## HISTORIC AND DESIGN REVIEW COMMISSION

**HDRC CASE NO:** 2017-066  
**ADDRESS:** 2450 ROOSEVELT AVE  
**LEGAL DESCRIPTION:** NCB 7456 BLK PT OF DIV 2 OR PT OF TR A 5 39 AC  
**ZONING:** I-1 RIO-5  
**CITY COUNCIL DIST.:** 3  
**APPLICANT:** Nicholas Melde/Alamo Architects  
**OWNER:** James Lifshutz  
**TYPE OF WORK:** Exterior modifications, creation of additional window openings  
**REQUEST:**

## **ROOSEVELT STUDIO APARTMENTS**

CONCEPT DESIGN: SITE PLAN

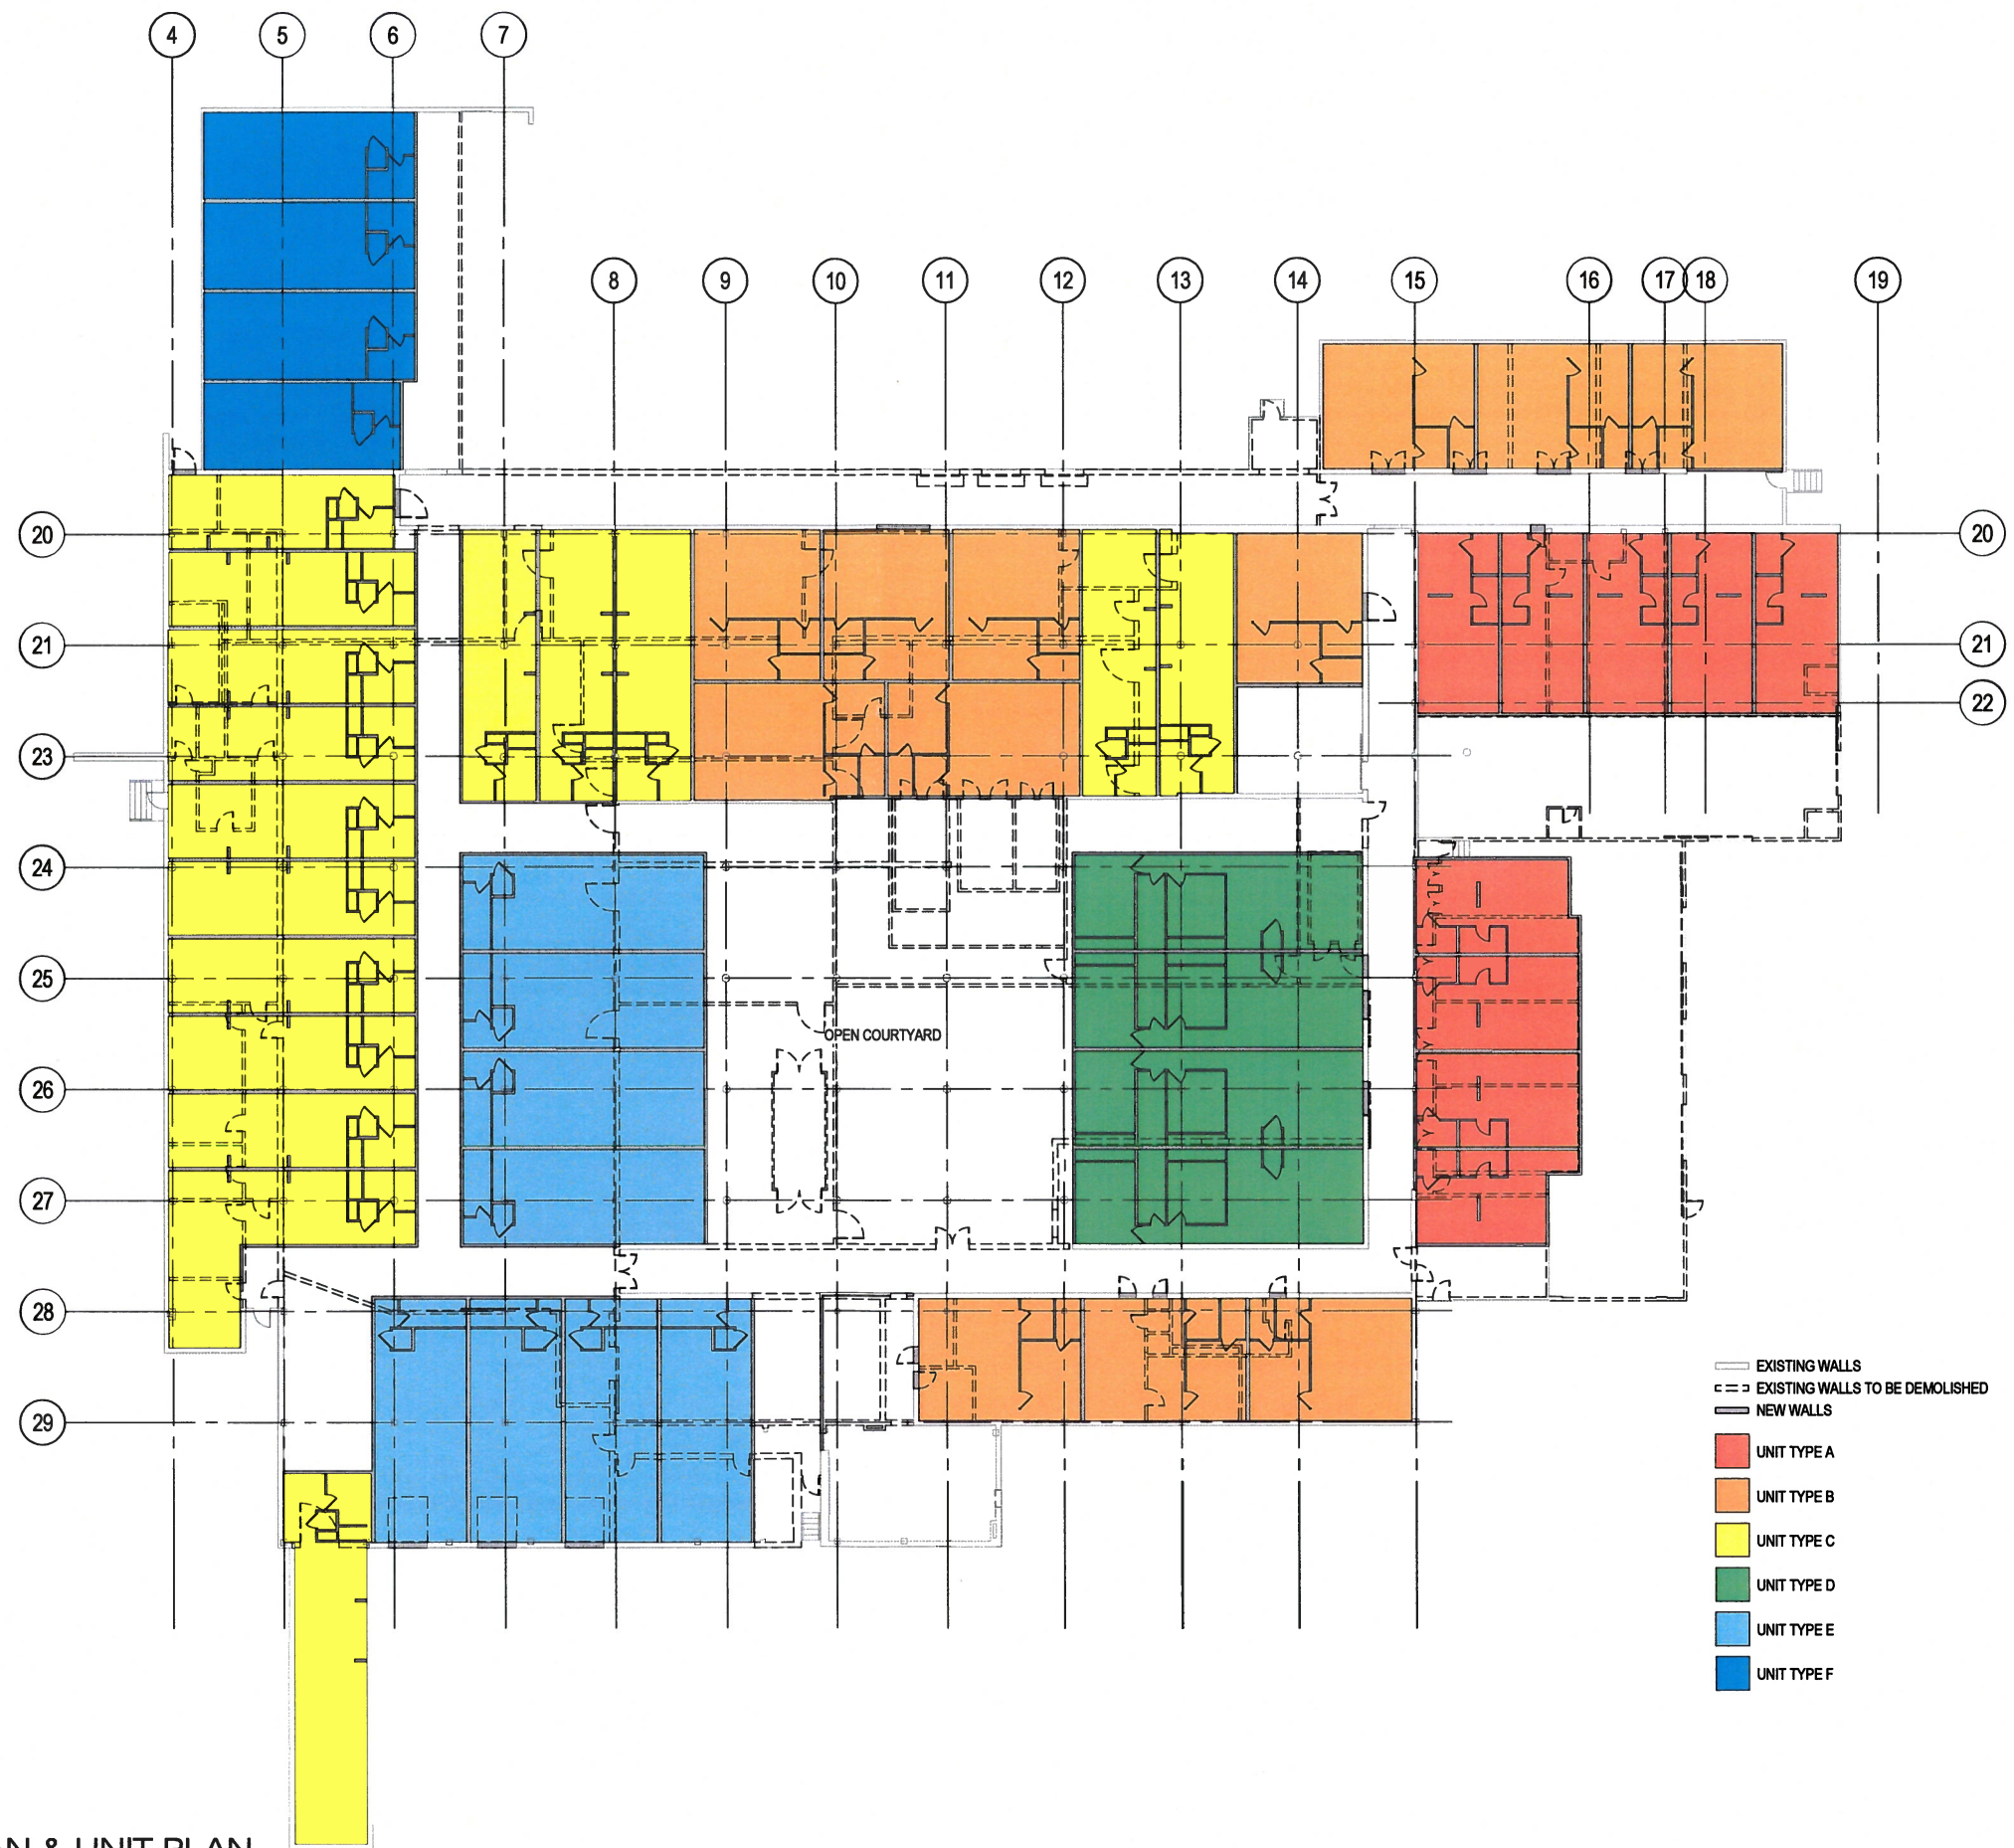
- h. COVERED PARKING – On the south façade of the existing structure, the applicant has proposed to construct covered parking. Staff finds the proposed location appropriate; however, the proposed parking shall be buffered from the public right of way by a screening element.

- i. That the applicant buffer all parking from the public right of way.
